**From:** Hartman, Thomas  
**Sent:** Tuesday, April 14, 2015 7:01 AM  
**To:** Brookhart, Lee  
**Subject:** FW: Callaway ISFSI - Deluge test pictures

**From:** Ptasznik, Elizabeth M [<mailto:EPTasznik@ameren.com>]  
**Sent:** Monday, April 13, 2015 7:33 PM  
**To:** DL CAL NRC Resident Inspectors  
**Cc:** Ewens, Steve E  
**Subject:** Callaway ISFSI - Deluge test pictures

Deluge Test:

Post-Deluge Test; Only slight wetting at the CEC baseplate

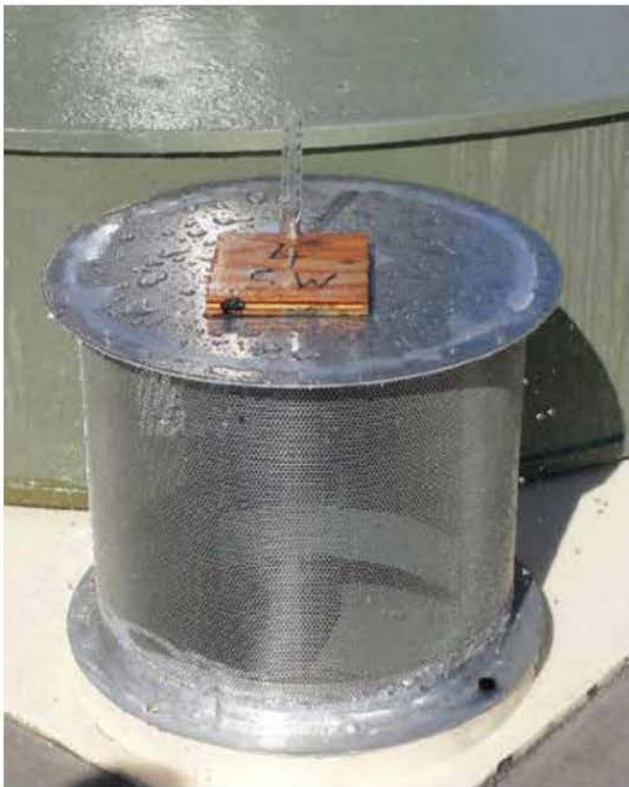
FYI. "Slight wetting" after the deluge test (last pic). It looks more than that to me.
